## Certificate of Appropriateness for 2122 Regent St

September 16, 2019

# Proposed Work

FRONT ELEVATION

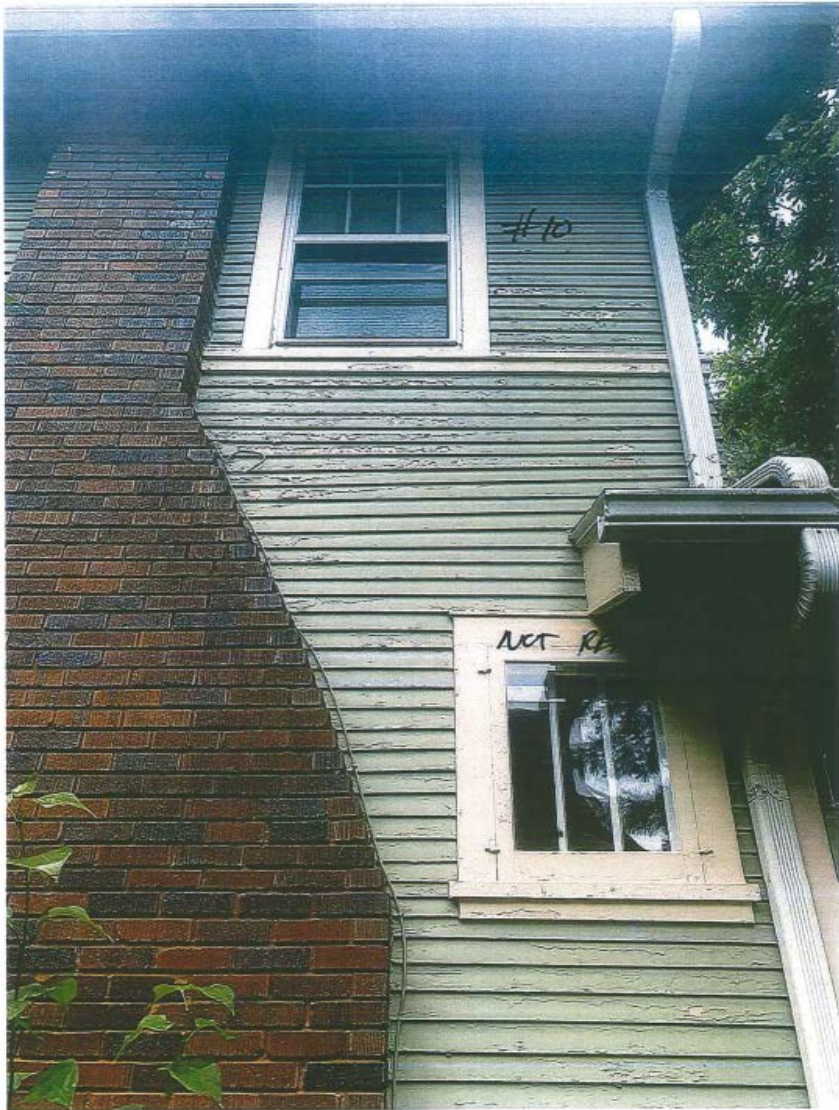
\* ~~NOT DOING~~ \*  
~~Porch enclosure #1~~

\* All windows on whole  
 house will have a whole  
 exterior

LEFT ELEVATION

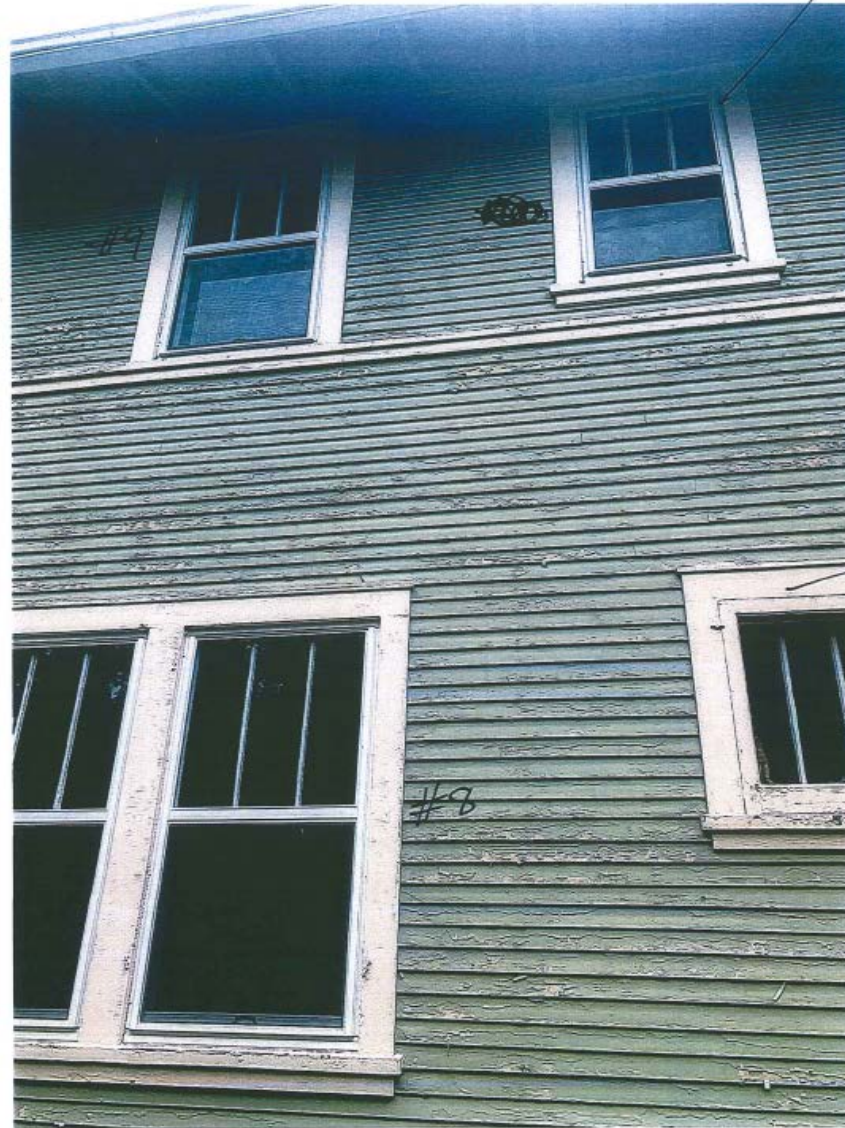
Not  
 Replacing
